*Plan Alternativo for NAICM**

Operational Viability Assessment Towards Increased Global Capacity

15 August 2018

- **This briefing provides a high-level summary of MITRE’s aeronautical assessment of the Plan Alternativo issued by Mexico’s MORENA party in late 2015**
 - The assessment is not an agreed-upon deliverable under the terms of any signed agreement between MITRE and another organization or group, and as such, it is informally provided to decision makers in Mexico on an “as is” basis
- **The briefing is intended for a general audience with some air navigation knowledge**

Plan Alternativo

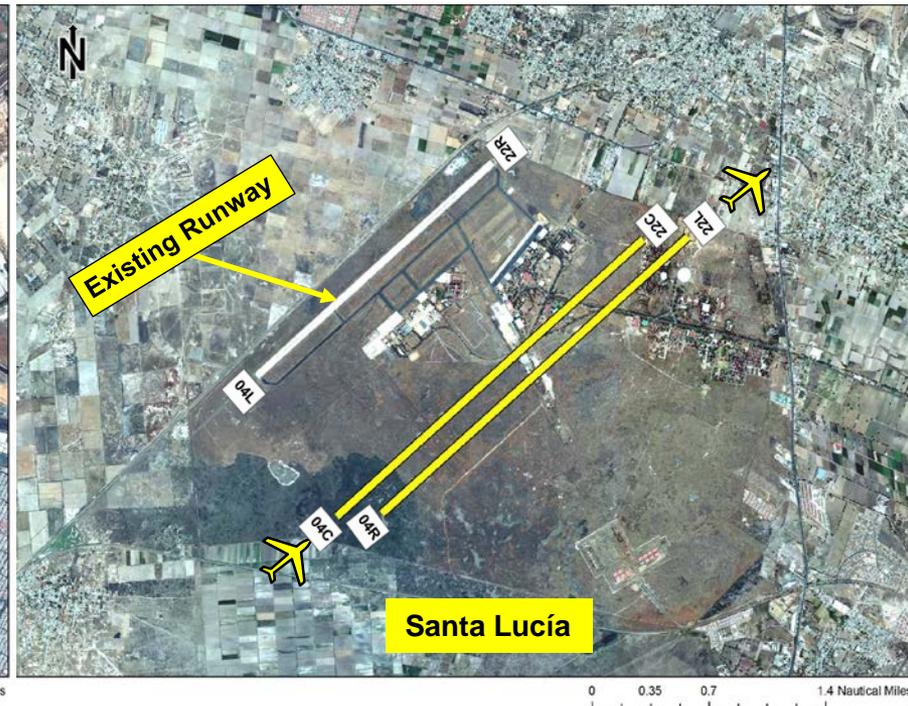
As the 2015 Plan Alternativo did not show parallel runways, MITRE modified them (to ensure parallel runways) to simplify procedure design and air navigation.

Plan Alternativo

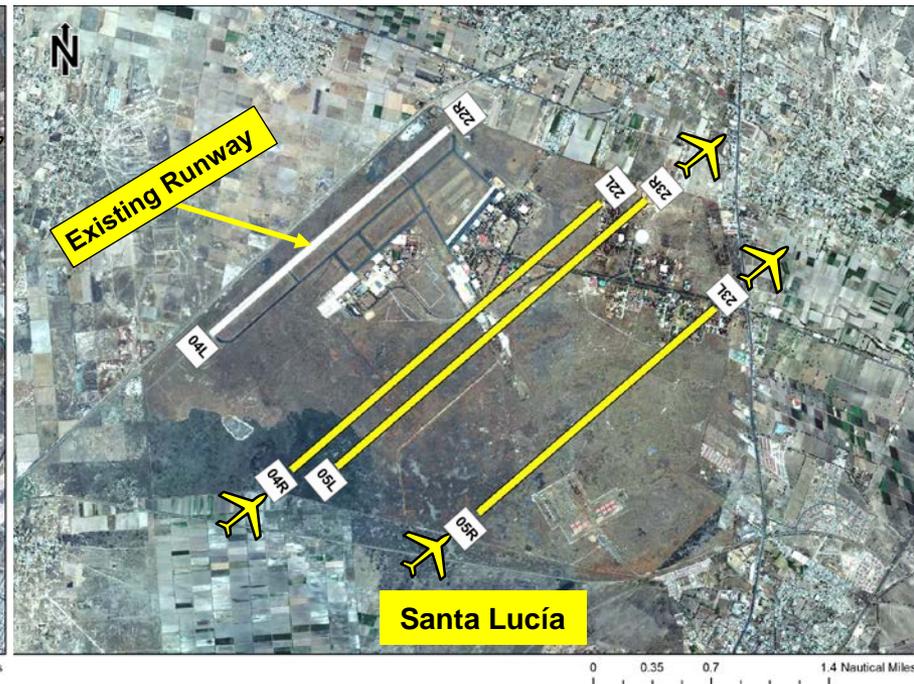
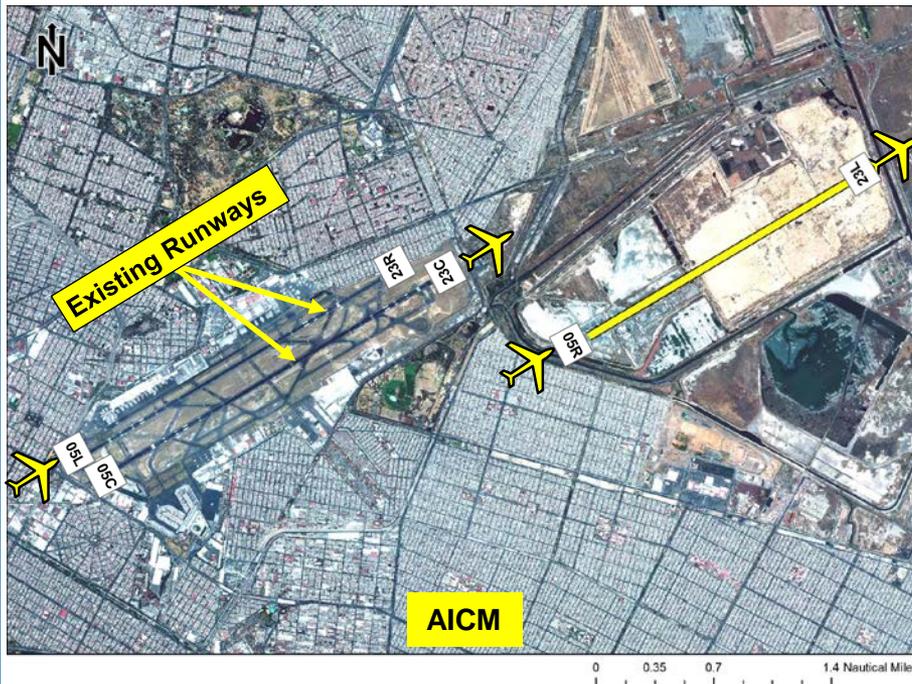
Notice an additional runway in the “Rellenos Sanitarios” area, located far from AICM’s terminals. As mentioned before, MITRE analyzed that area in the year 2000 and found it to be unfeasible.

The runways are deemed by MITRE too short (approach lights require, *each direction*, 900 m., i.e., 1.8 km), to achieve maximum payload and reach many long-range destinations. While less so, AICM is also limited. Thus, Santa Lucía and AICM would remain limited. **MITRE**

Radar Tracks Showing Typical Arrival Paths to AICM Today

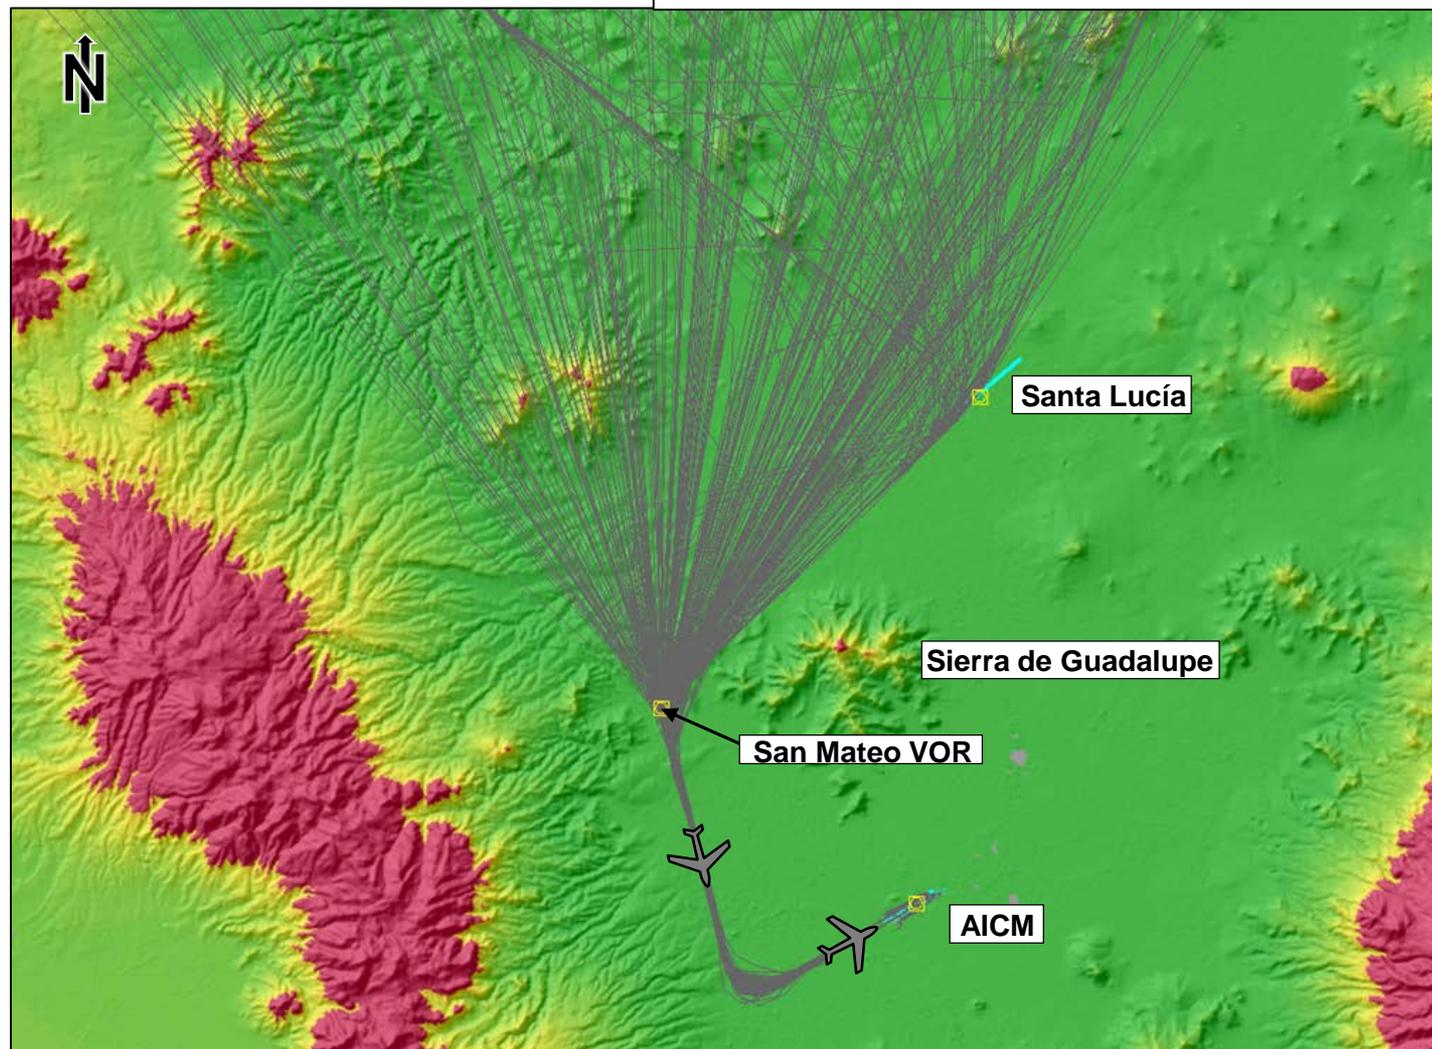
This large flight concentration, through the San Mateo VOR, is an unintended consequence of the traffic volume at AICM. NAICM procedures would eliminate such a concentration of traffic.

Single Approach to AICM and (simultaneously) Single Approach to Santa Lucía

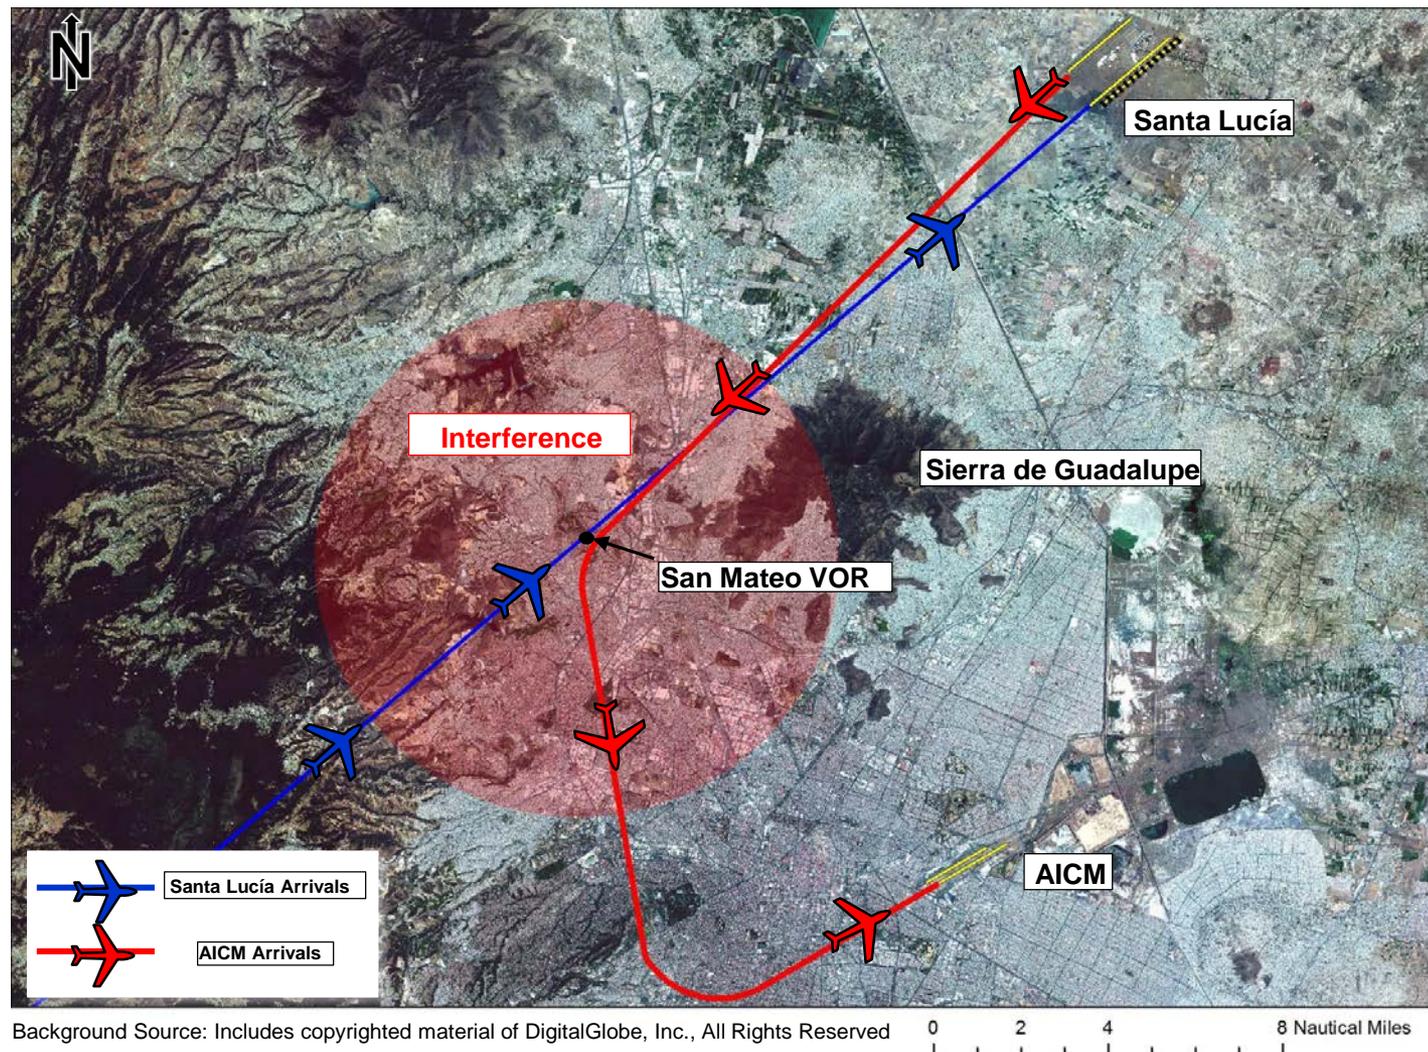
While the red line represents the combined published arrival/approach to AICM, many flights are routed directly to the San Mateo VOR (as shown in a previous slide), from many other directions, mostly through radar vectoring.

- **Single approach to each airport (conventional procedures)**
 - Creates an unacceptable area of interference at the San Mateo VOR
 - To ensure safety, long aircraft separations would be required and, as a result, global runway capacity in the area would not grow, leading to increasing delays, thus failing to resolve the enormous saturation levels at AICM

Single Approach to AICM and (simultaneously) Dual Approaches to Santa Lucía

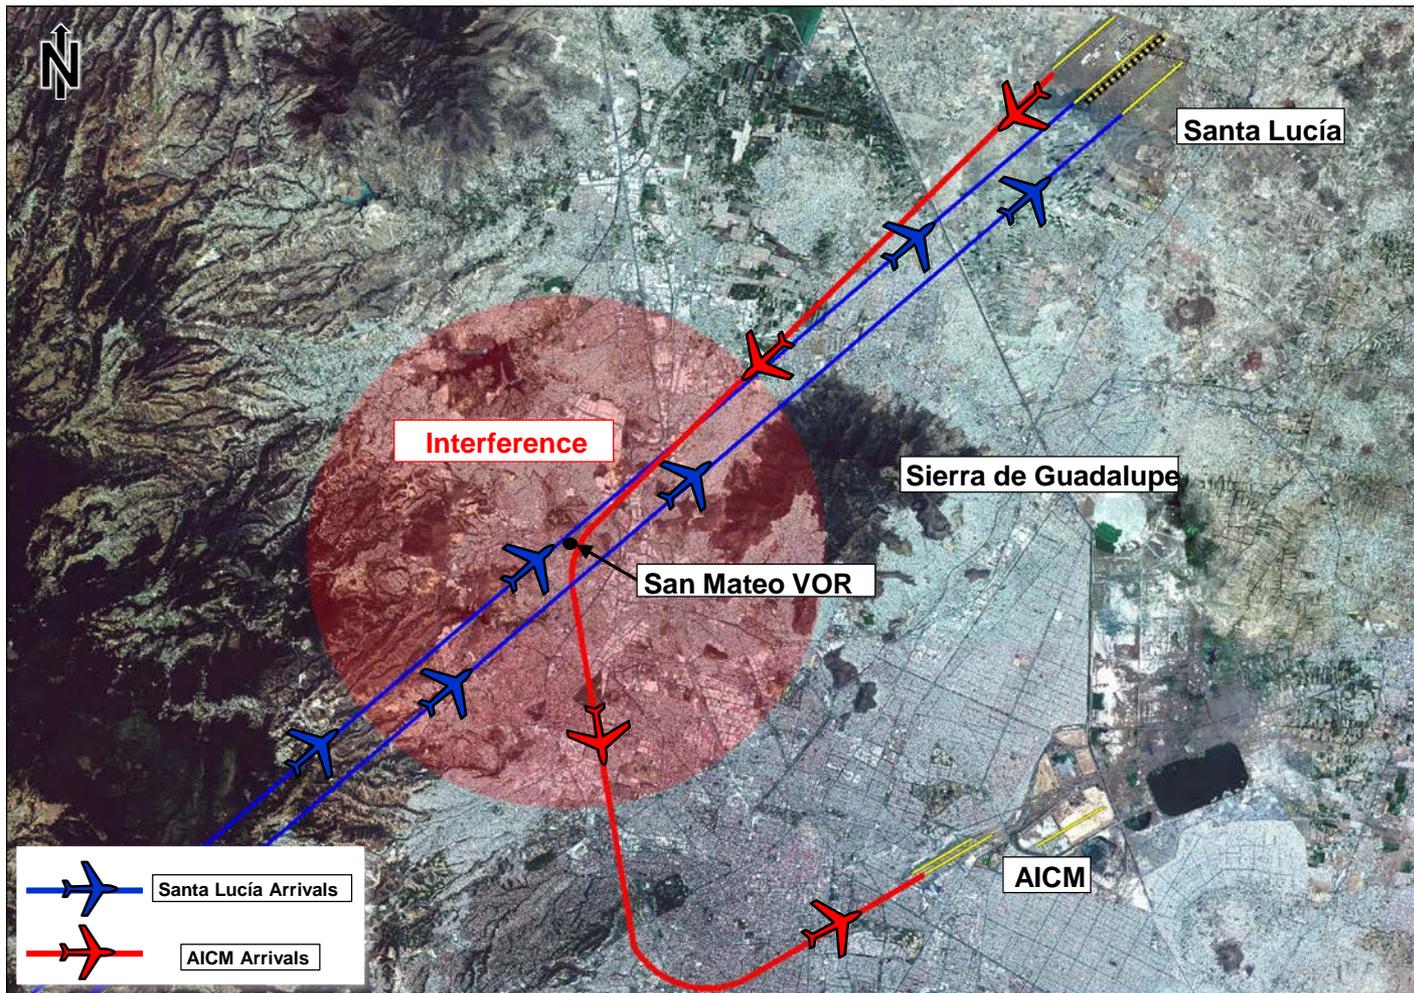
While the red line represents the combined published arrival/approach to AICM, many flights are routed directly to the San Mateo VOR (as shown in a previous slide), from many other directions, mostly through radar vectoring.

The blue lines represents what a two-runway simultaneous approach to Santa Lucía might look like, with one track very close to Sierra de Guadalupe.

- **A single approach to AICM and dual approaches to Santa Lucía (conventional procedures)**
 - Creates an unacceptable area of interference at the San Mateo VOR
 - Dual approaches only exacerbates the problem
 - Due to the proximity of Sierra de Guadalupe, approaches to Santa Lucía “on the right” would be very complex when dealing with breakout maneuvers, weather avoidance, and other non-standard flight conditions such as unstable approaches
 - Increased airspace traffic complexity at both airports would likely lead to additional delays
 - To ensure safety, longer aircraft separations (than those mentioned in the top bullet) would be required and runway capacity would not only not grow, but, paradoxically, airspace complexity may lead to larger delays
